Category D	Repair Guidance	Ref No. R041/96	Page 1 of 3
Coverage <input type="checkbox"/> Distributor only <input checked="" type="checkbox"/> Please inform to your dealers		Date issued August 26, 1996	
Please convey this information to your <input type="checkbox"/> Director <input type="checkbox"/> General Manager <input checked="" type="checkbox"/> Warranty Dept. <input checked="" type="checkbox"/> Parts Dept. <input checked="" type="checkbox"/> Training Dept. <input checked="" type="checkbox"/> Field Rep		Date Revised	
Applied Model 626/MX-6(GE) with FP, FS engine		Applied Country or Specification Worldwide

Subject: **HLA Noise at Idling**

Oil Pump

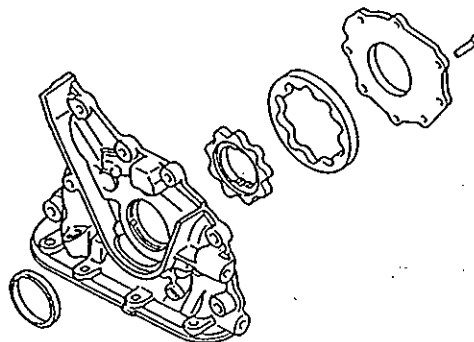
The HLA noise may occur at idling with normal engine operating temperature. This problem is most likely to occur at idling after high speed driving.

The oil pump control plunger is worn excessively, and this causes air to be sucked up into the oil pump. The air bubbles are delivered to the HLA, resulting in the noise.

Control Plunger

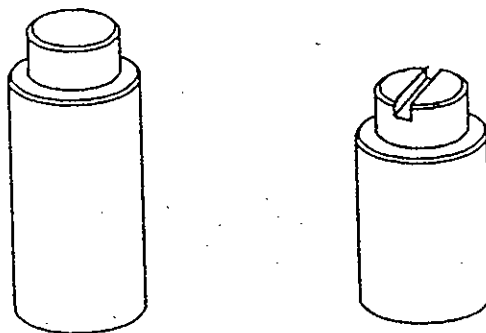
1. Surface treatment has been added to the control plunger to prevent excessive wear.
2. A slit has been added to the top of the plunger so that the plunger operates within its specified oil pressure.

When you encounter a customer complaint of this concern, replace the control plunger with a modified one.
